CLAREMONT BUSINESS PARK 2 FIL. NO. 1 - LOT 2

EL PASO COUNTY, STATE OF COLORADO GRADING & EROSION CONTROL PLAN

EPC STORMWATER REVIEW COMMENTS ARE SHOWN IN ORANGE BOXES WITH BLACK TEXT

GRADING & EROSION CONTROL PLAN
CLAREMONT BUSINESS PARK 2 FIL. NO. 1 - LOT 2
JOB NO. 44-037
DATE PREPARED: OCTOBER 9, 2020
DATE REVISED:

GRADING & EROSION CONTROL PLAN
CLAREMONT BUSINESS PARK 2 FIL. NO. 1 - LOT 2
JOB NO. 44-037
DATE PREPARED: OCTOBER 09, 2020
DATE REVISED:

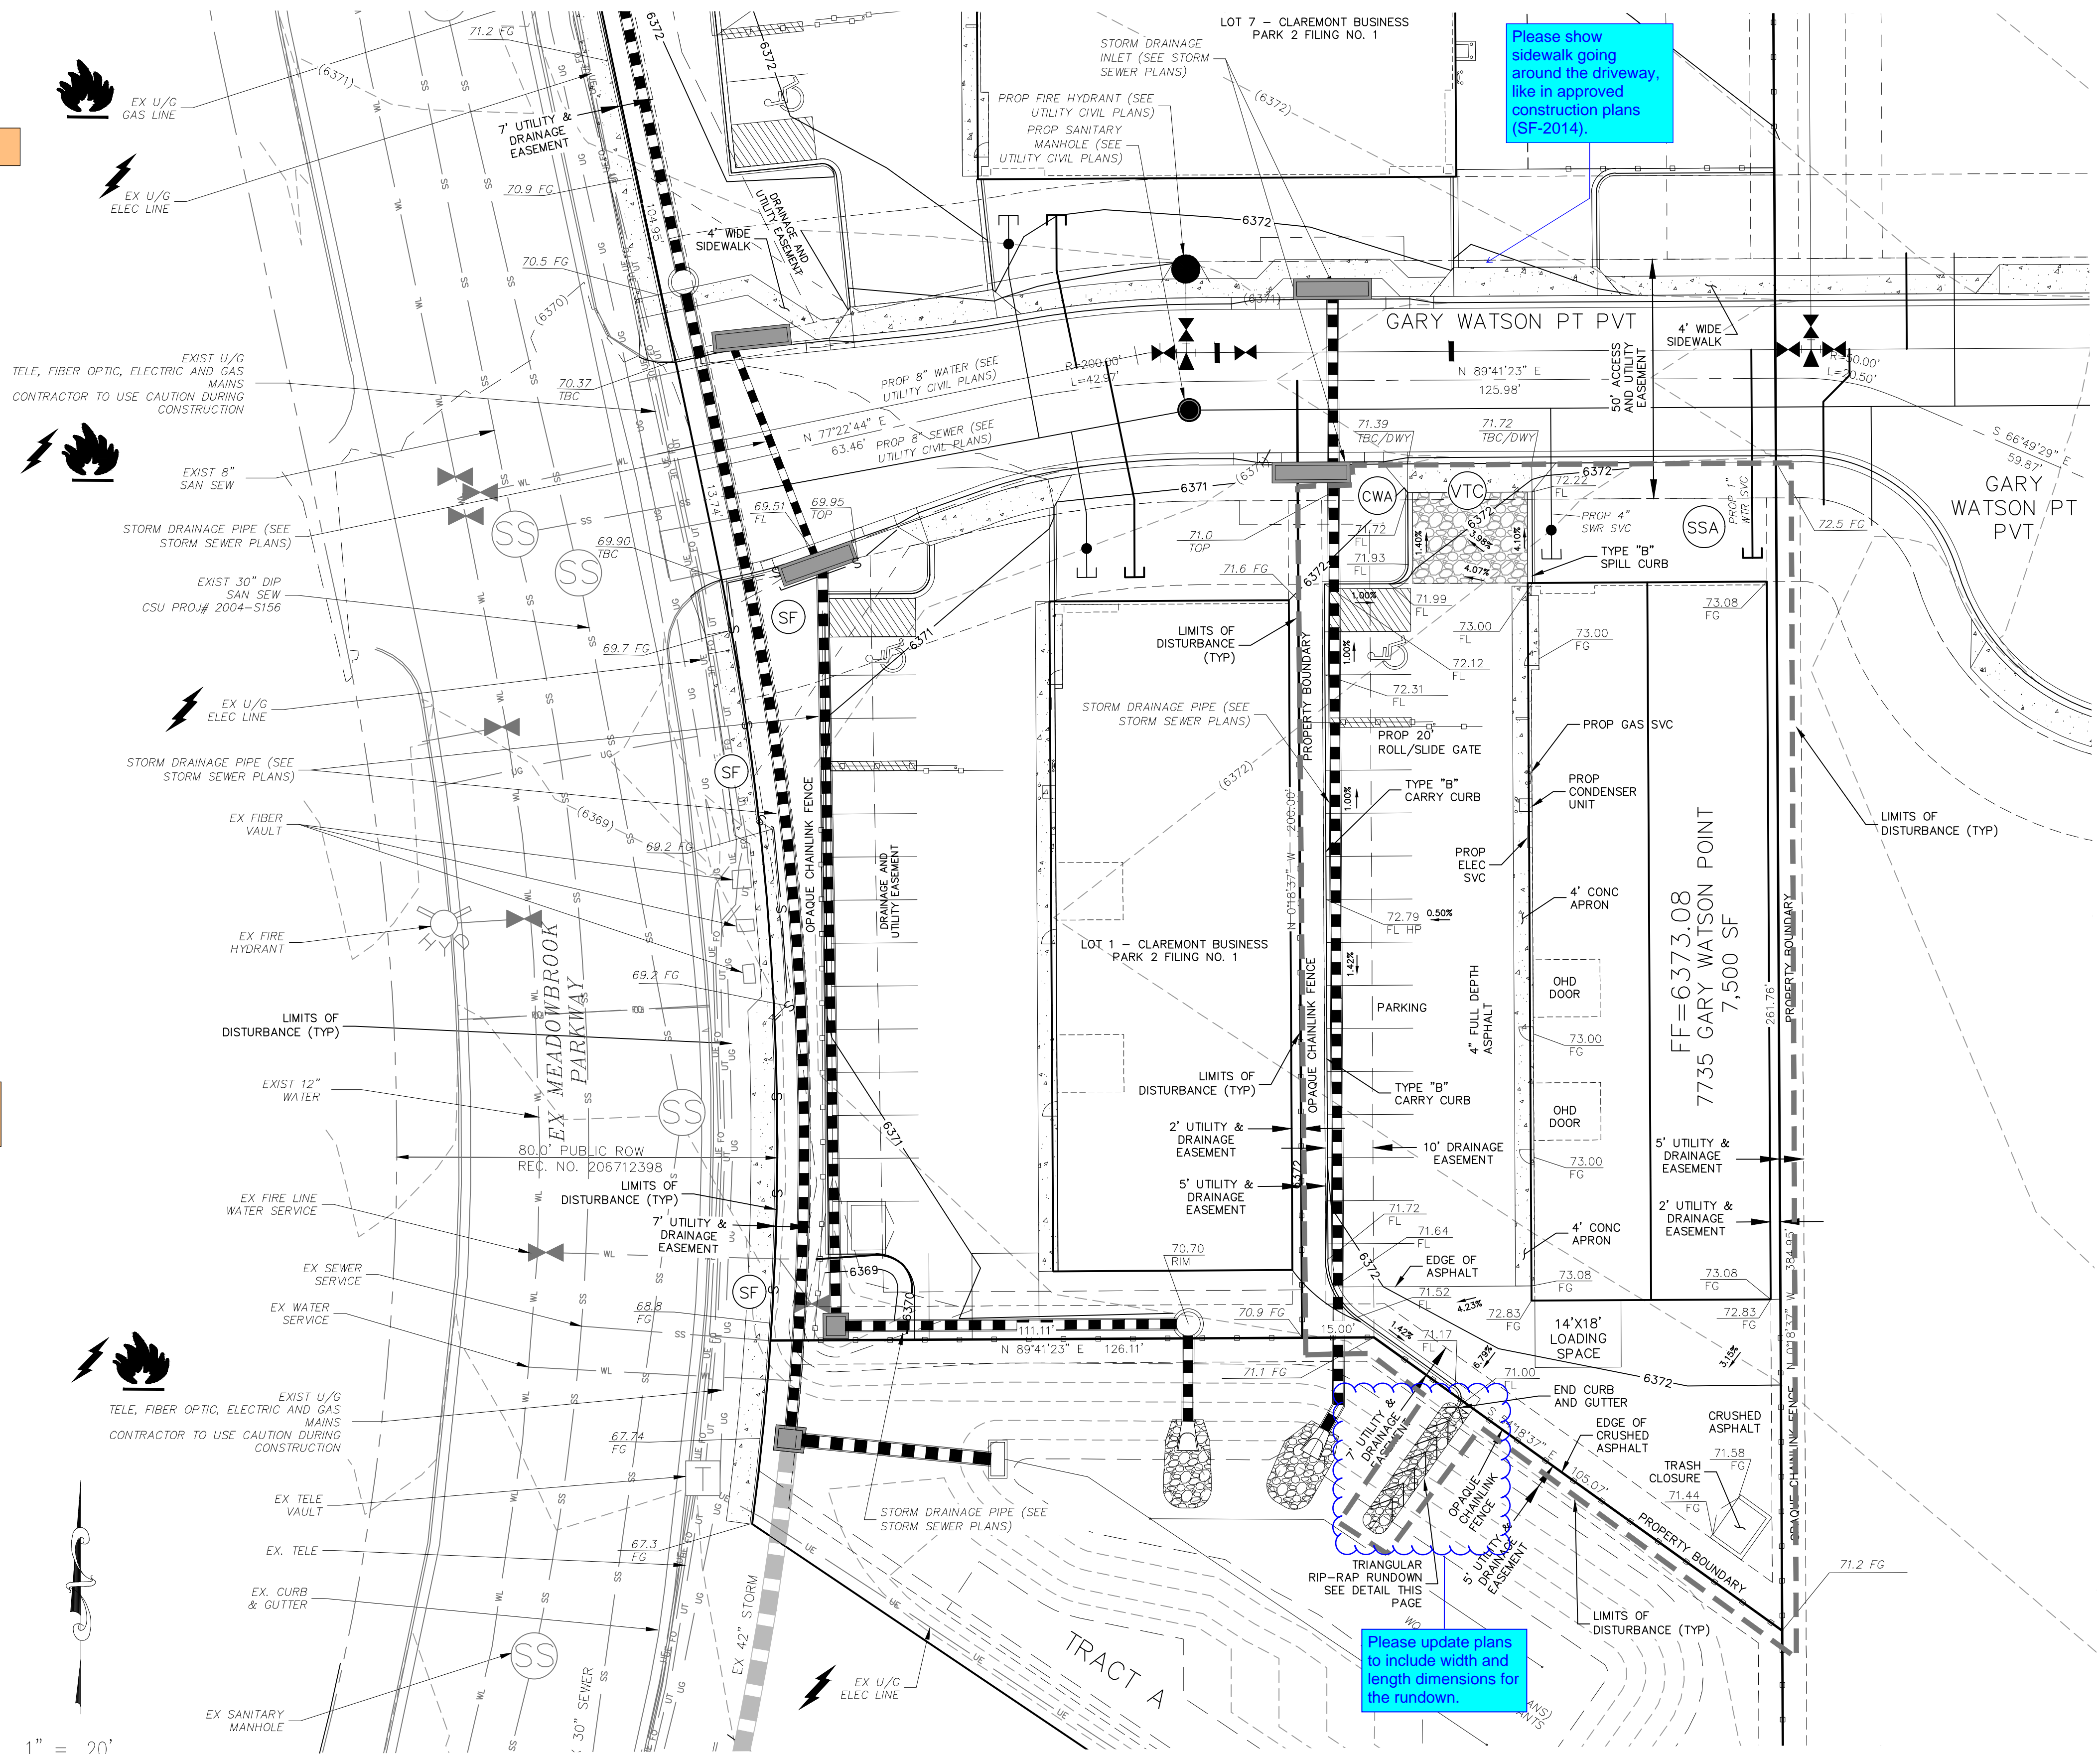
show silt fence locations on figure

Label all proposed temporary construction control measures by phase of implementation (initial, interim, final)
Provide BMP Details

If "limits of disturbance" and "construction boundary" are the same, change to "construction boundary/limits of disturbance" or otherwise show as separate line types for each on the legend and figure.

Provide riprap gradation table and note that CDOT Section 506 Requirements apply

Add a note about existing vegetation and percent cover (prior to early grading).
Add a note stating no asphalt/concrete batch plants are associated with this project.
Add a note stating there are no springs, streams, or wetlands at the Site.
Add a note stating that all cut/fill activities were completed under EGP204

Please show sidewalk going around the driveway, like in approved construction plans (SF-2014).

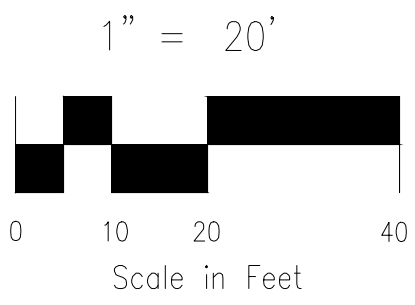
Please update plans to include width and length dimensions for the rundown.
